1 Products affected

UL upgrade from UL 498 to UL 60320-1.
Marking for UL rating 7A/125V~ added. CSA / UR replaced by cURus.

Product Change Notification					2561 Change of marking		
owner	creation date	release date	released by	change order no	rev	page	D10-052-362
zeierjo	31.03.2021	31.03.2021	muehlema	2019985	B	1 of 1

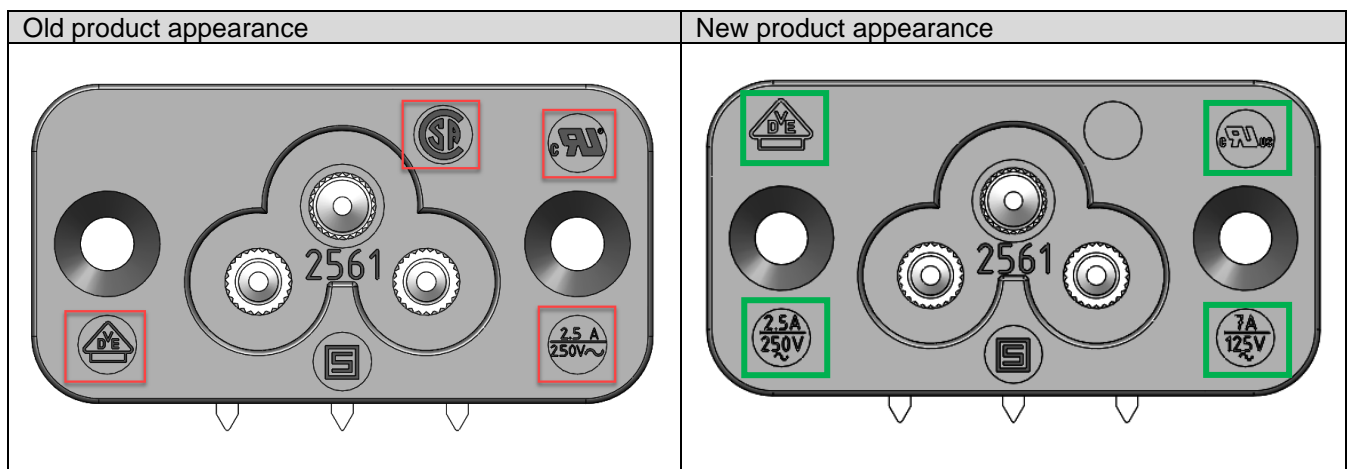
Form	Yes	Change of approval and rating marking.
Fit	No	-
Function	No	-
Manufacturing	No	-
Label	No	-
Packaging	No	-
